Work Order ID 157545

Item Name: Basket Hoop

D3166-1 BASKET HOOP

DRAWING NO. D3166	TITLE BASKET HOOP	REV A1	DART AEROSPACE LTD ENGINEERING ORDER		D.E.O. NO. D3166-A-2	SHEET NO. 1 OF 1	SCALE NTS
DRAWN AJS	CHECKED <i>[Signature]</i>	MFG. APPR. <i>[Signature]</i>	APPROVED <i>[Signature]</i>		DE APPR. <i>[Signature]</i>		
DATE 08.12.11	DATE 08.12.15	DATE 08/12/15	DATE 08/12/16		DATE 08.12.16

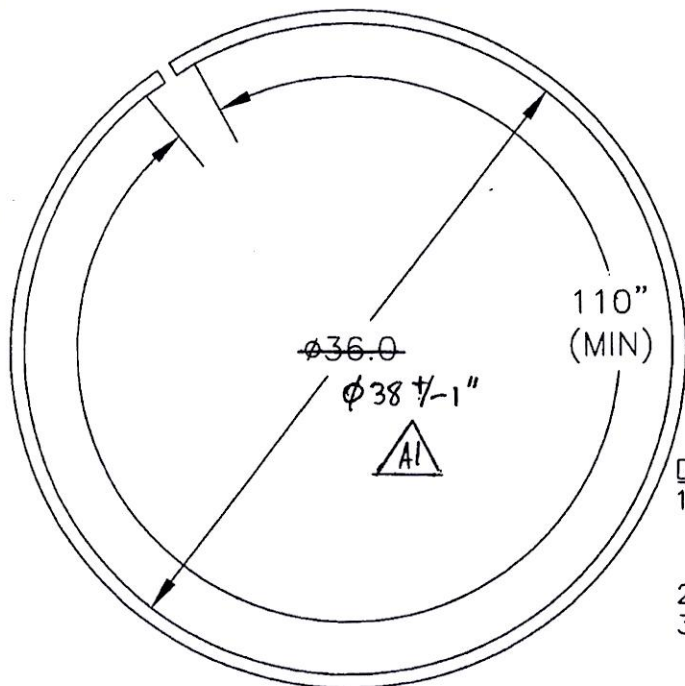
DESIGN #	DRAWN BY CP	DART AEROSPACE LTD HAWKESBURY, ONTARIO, CANADA	
CHECKED #	APPROVED #	DRAWING NO. D3166	REV. A SHEET 1 OF 1
DATE 02.07.10		TITLE BASKET HOOP	SCALE NTS
A	02.07.10	NEW ISSUE	
A1	04.04.08	38+/-1 WAS 36.0

10.6 (REF, NEED 8.0 MIN)

1) MODIFY MATERIAL NOTE FOR D3166-1 AS SHOWN:

2) MODIFY MATERIAL NOTE FOR D3166-3 AS SHOWN:

IS:

1) MATERIAL: AISI 304/316 SS, 3/4 X 3/4 X 0.065 WALL SQUARE TUBING,
60.00" LONG
REF. DART SPEC M304TS0.750W.065

IS:

1) MATERIAL: AISI 304/316 SS, 3/4 X 3/4 X 0.065 WALL SQUARE TUBING,
120.00" LONG
REF. DART SPEC M304TS0.750W.065
